City of Prattville Historic Preservation Commission

**CITY OF PRATTVILLE
HISTORIC PRESERVATION COMMISSION
MINUTES
May 26, 2016**

Planning Department Staff Report

246 Wetumpka Street – CA1605-01

EXIST FRONT ELEVATION

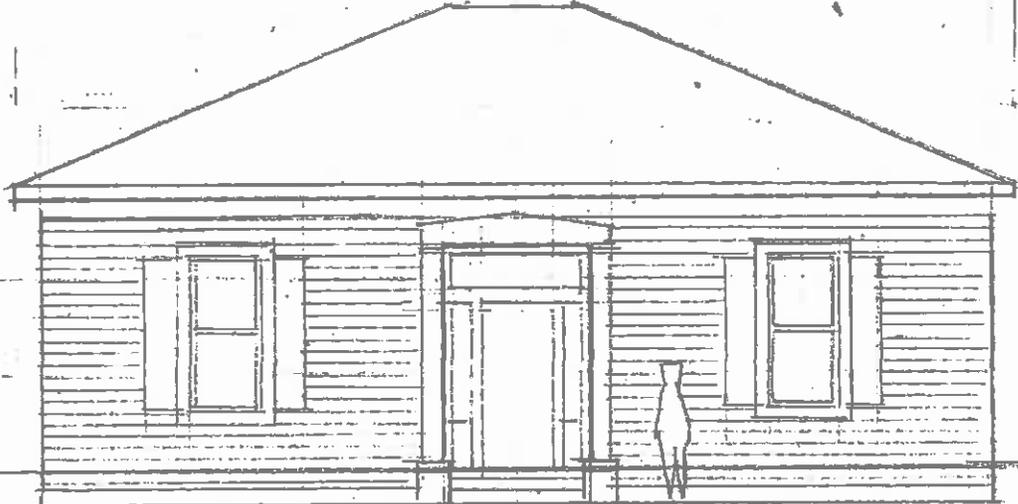
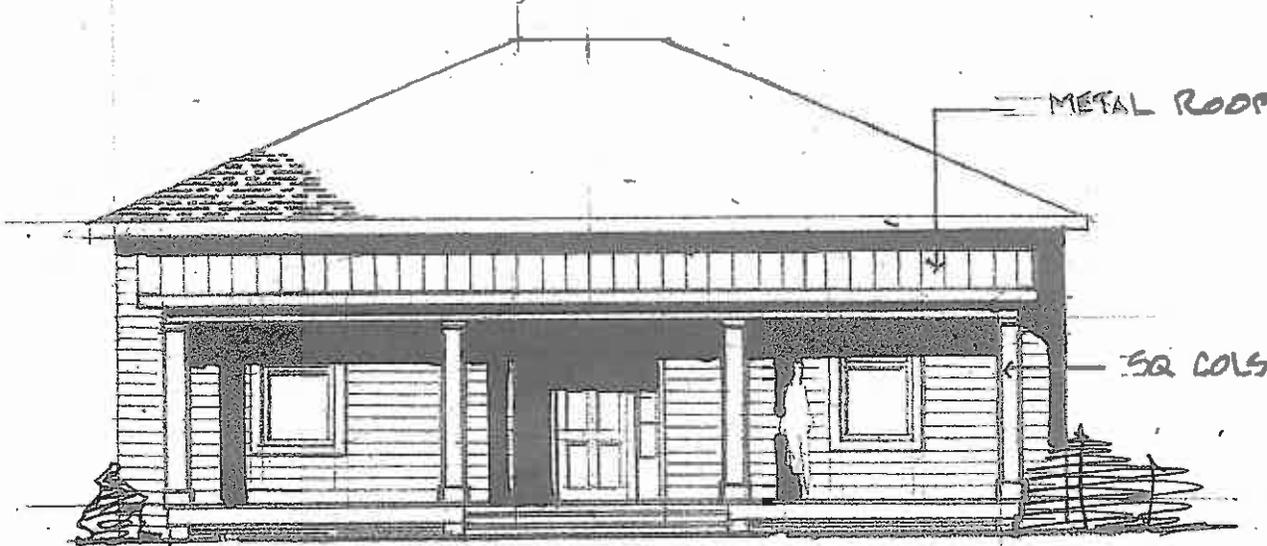
Staff Comments: The proposed modification will restore a porch that was apparently removed by a previous owner. The removal occurred prior to the house being describing in the 1984 National Register listing (see above). Unfortunately, a search of records by the applicant and the Planning Department has not uncovered a description or a picture of the earlier porch. The 1925 Sanborn Map of Prattville (Attachment B) indicates the presence of front porch across the front of the house and wrapping around the front east corner. It is clear that pilasters and pediment surrounding the front door were added after removal of the porch.

A PORCH ADDITION
246 WETUMPKA STREET
PRATTVILLE, AL
FOR MATT HOLTZSCHLER

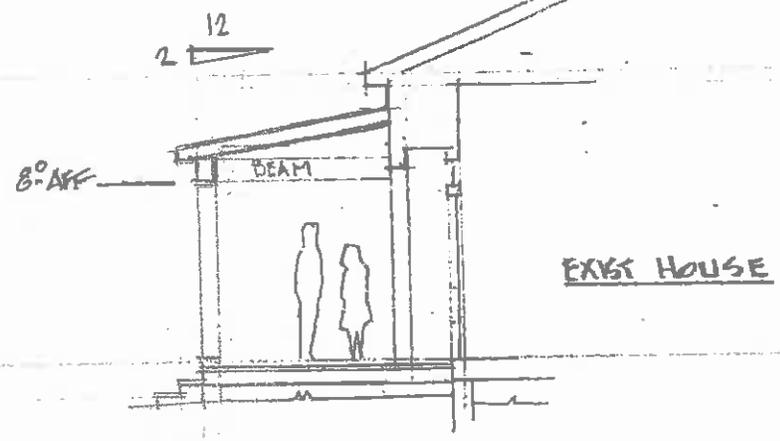
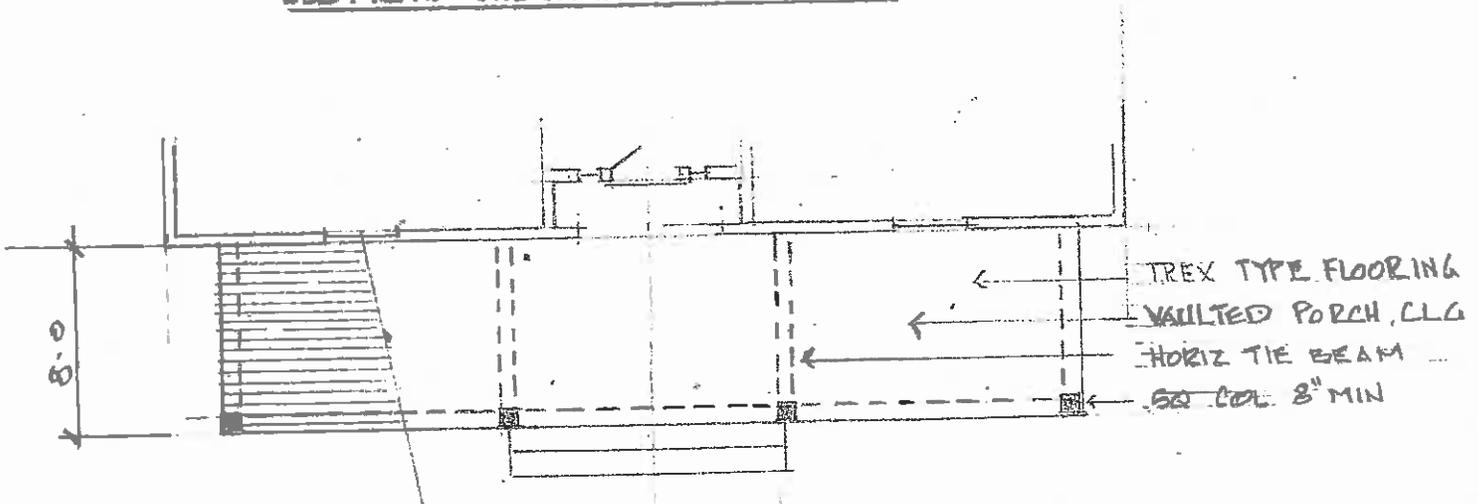
Item 1 – Remove existing pediment and pilasters surrounding front door. Add 36.5' wide, 8' deep front porch with standing seam metal roof

Without a drawing or photograph of the original porch, the owner must design a porch that is consistent with the structure's style and the Commission's guidelines. The present design is consistent with the relatively unadorned structure. The porch design leaves the top of the front door visible from the street and protects the existing cornice and frieze. The porch design uses natural materials except for the Hardi trim boards and Trek as the floor decking. The Hardi material has been permitted by the board, but the use of Trek has been discouraged. Recommend switching the decking to wood boards.

Staff Comment: As long as the shape and underlying construction of the porch ceiling and roof are retained, replacement of the asphalt shingles with metal should be allowed. The Commission should retain final approval over the style of the standing-seam metal panels. It is also appropriate for the Commission to approve or disapprove the color to maintain compatibility with the shingle roof on the remainder of the structure.

Alteration-approved as submitted contingent that the porch flooring is tongue and groove.

Recommendation: Approval of Item 1 with minor modifications to match guidelines

Approve Item 2.
